SAND 79-1414  
UNLIMITED RELEASE  
PRINTED DECEMBER 1979

ANALYSIS OF WEST HACKBERRY INTERIM WITHDRAWAL SYSTEM

ABSTRACT

FIGURE 1  
SCHEMATIC OF INTERIM WITHDRAWAL SYSTEM

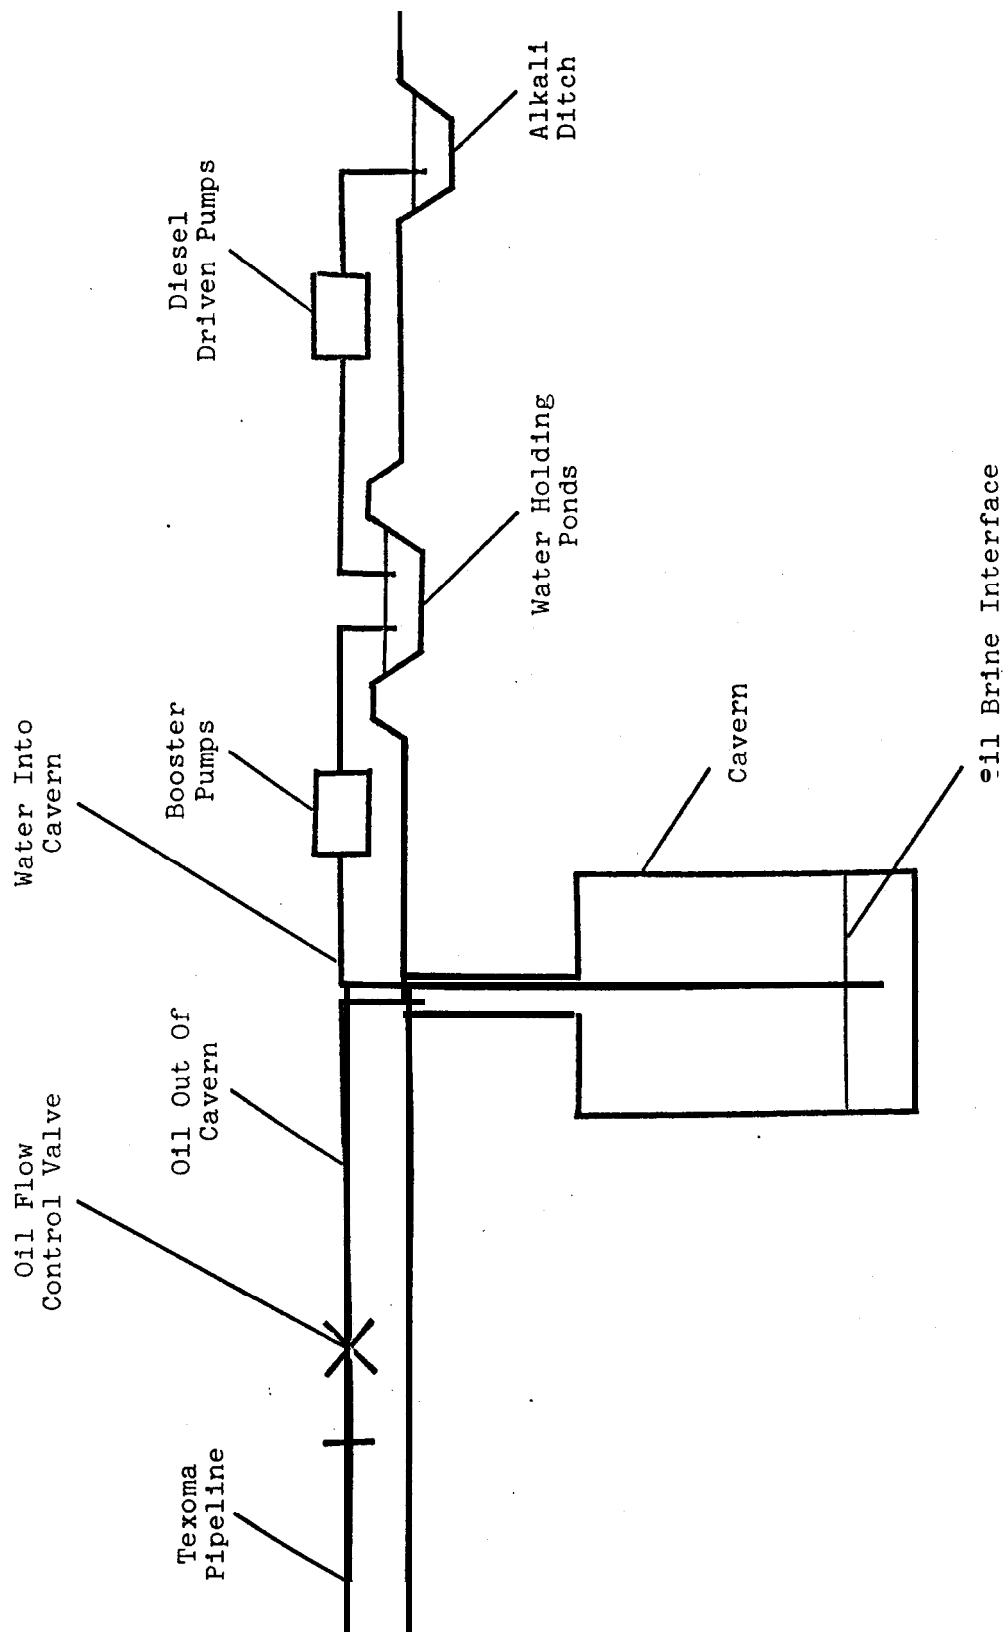
The valve schedule listing was reviewed in detail and several discrepancies were noted. Oil cannot be pumped off the site

with the valve schedule of the plan. It appears that reversal of valves 20F-4 and 20W-2 in the plan would be required. Oil from cavern 11 cannot be pumped off the site without also opening valve 20F-2 and either 20F-1 or a combination of other valves, which are not included in the valve schedule.

1. Valve 20F-5 should be listed with the water line instead of the brine manifold.
2. valve 520G should be labeled 520E-1.
3. The reason for the various (four ) "Erine System" schedules needs to be clarified. These were uninterpretable as to their intent.

Some discrepancies were noted between the "design" [3] and "as built" [4] drawings. One example is the reversal of labeling for oil lines #10CC-0034C and #10CC-0035C.
